**Response to U.S. EPR Design Certification Application RAI No. 265, Supplement 2**

**Request for Additional Information No. 265, Supplement 2**

**U. S. EPR Standard Design Certification**

**SRP Section: 03.06.03 - Leak-Before-Break Evaluation Procedures**

Figure 03.06.03-21-1—Comparison between Aged and Unaged Data

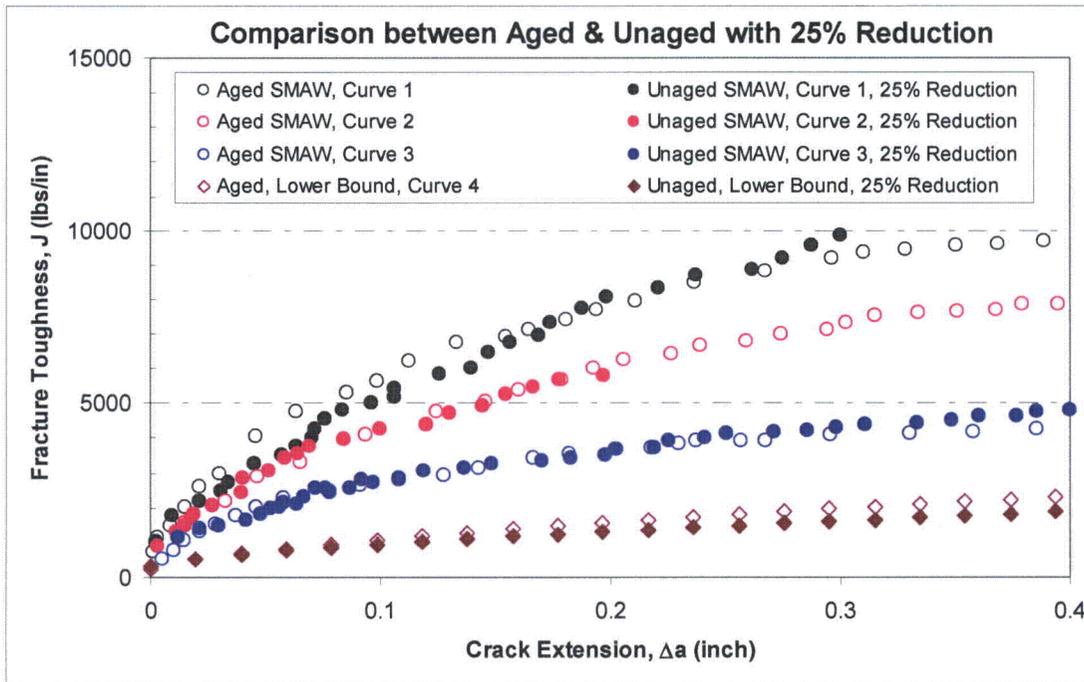
The 30-percent reduction seems to be in reasonable agreement with NUREG/CR-6428 ("Effects of Thermal Aging on Fracture Toughness and Charpy-Impact Strength of Stainless Steel Pipe Welds" by Argonne.) However, AREVA needs to review NUREG/CR-6428 and include their assessment of the NUREG and the level of support that the NUREG provides to their response.

[ ] . Because of its greater aging time and temperature, the data set from Reference 1 is a lower bound toughness data set for 316 GTAW/TIG welds. Four sets of public data (Reference 1 through Reference 4) fall below the data in Reference 1 (16-8-2 material aged for 100,000 hours at 900°F) as shown in Figure 03.06.03-21-1.

Reference 1 through Reference 4, shown in Table 03.06.03-21-1, are bounded by Huang's 16-8-2 data set, as shown in Figure 03.06.03-21-1.

NUREG/CR-6428 also summarizes unaged fracture toughness J-R curve data compiled in the Pipe Fracture (PIFRAC) database as well as data from other published sources. The unaged data are shown in Figure 15 of NUREG/CR-6428 for both room and operating temperatures (288°C to 427°C (550°F to 800°F)). These results indicated that the fracture toughness properties are insensitive to filler metal; however, they are sensitive to the welding process used with gas tungsten arc weld (GTAW) exhibiting higher toughness than SMAWs or SAWs. The available fracture toughness J-R curves for aged SMAWs, submerged arc welds (SAW), and GTAWs are shown in Figure 16 of NUREG/CR-6428 for both room and operating temperature of 288°C (550°F). In these studies the aging time and temperature was sufficient to achieve saturation. It is the effect of thermal aging at operating temperature that is of particular interest. At operating temperature, Figure 16 NUREG/CR-6428 only provides aged J-R curves for the SMAW welding process. There are four sets of aged J-R curves presented on this figure. These aged data are then compared against what are considered to be the corresponding unaged data from Figure 15 of NUREG/CR-6428 and shown in Figure 03.06.03-21-1. The results of Figure 03.06.03-21-1 show that a 25 percent reduction due to thermal aging (for operating temperature condition) best describes the data from NUREG/CR-6428.

In Reference 1, the NRC stated that the Japanese nuclear pipe flaw evaluation codes (JSME) and Japanese pipe fracture tests has shown that the GTAW toughness is comparable to SMAW welds. Based on this information, it is reasonable to consider the aged SMAW weld data of NUREG/CR-6428 for the U.S. EPR stainless steel welds even though it uses the GTAW process. It is concluded that to account for the effects of thermal aging of the U.S. EPR stainless steel welds, the J-R curve at operating temperature needs to be reduced by at least 25 percent.
